INTERNATIONAL STANDARD ISO/IEC 23003-3:2012
TECHNICAL CORRIGENDUM 1

Information technology — MPEG audio technologies —
Part 3:
Unified speech and audio coding

TECHNICAL CORRIGENDUM 1

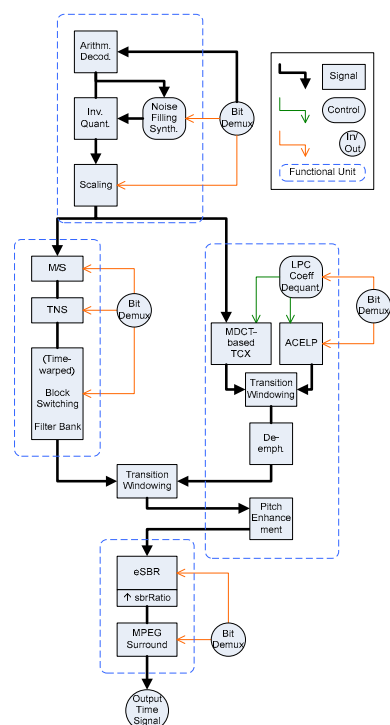
In 4.1 replace the diagram:

with:
